# Mode Selectable Switch

**Subgroup EV**

**2015/04/14**

## Proposal for the mode selection – alternative solution(text):

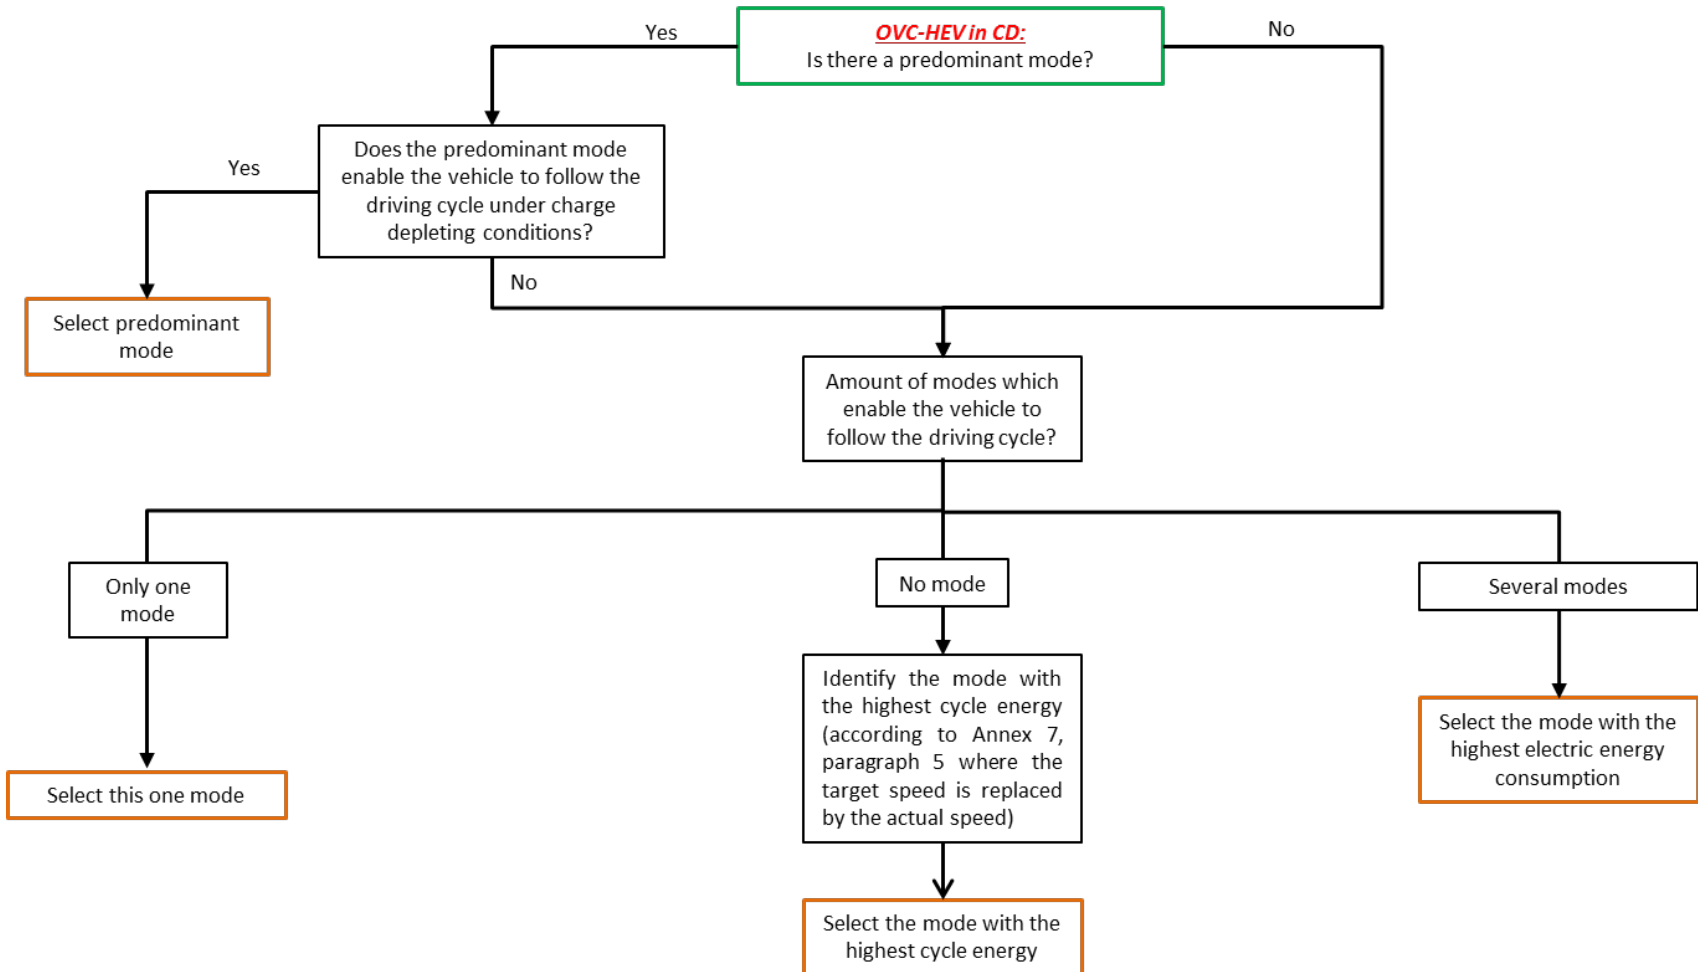
For vehicles equipped with a driver-selectable operating mode:

1. If there is a predominant mode that does enable the vehicle to follow the applicable test cycle (within the speed trace tolerances according to Annex 6, paragraph 1.2.6.6.), this mode shall be selected.
2. If there is no predominant mode or if there is a predominant mode but the predominant mode does not enable the vehicle to follow the applicable test cycle (within the speed trace tolerances according to Annex 6, paragraph 1.2.6.6.), the test shall be performed by using a mode that enables the vehicle to follow the applicable test cycle (within the speed trace tolerances according to Annex 6, paragraph 1.2.6.6.). If this is a single mode, this mode shall be selected. If several modes are capable of following the applicable test cycle (within the speed trace tolerances according to Annex 6, paragraph 1.2.6.6.), the most electric energy consuming mode of those shall be selected.
